# 3199 Van Aken Boulevard

For a variance to the rear yard setback.

**STAFF REPORT**

**3199 Van Aken Boulevard**  
Pace Residence  
Case#: ZON26-000001

## EXTERIOR VIEW

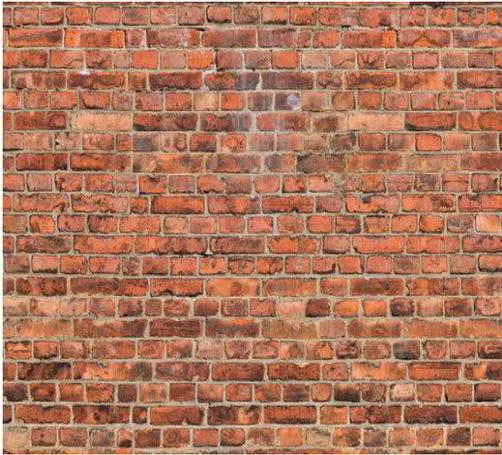
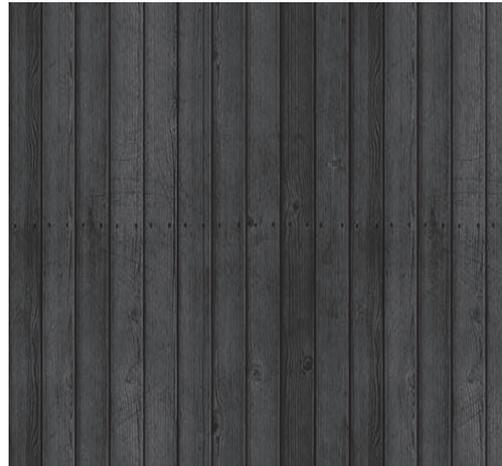
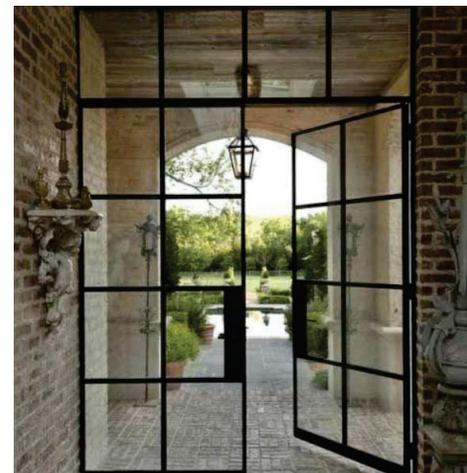
7. The Architectural Board of Review reviewed the house and garage addition design at their June 17, 2025 and again at the December 15, 2025 meetings with the following comments:

- a. study the vertical wood section as the focal point and the brick areas as background.
  - b. the brick area should be held back from or the vertical siding section pushed out to create a different plane between them on the west elevation.

- c. suggest the brick area roof be flat with only the vertical siding section having an angled roof.
  - d. create a hierarchy around the addition and coordinate windows and window colors.

- e. study removal of the vertical dark lines on the front elevation of the addition
8. The applicant also proposes a code conforming circular driveway in the front yard. Staff will administratively review a landscape plan for the driveway.
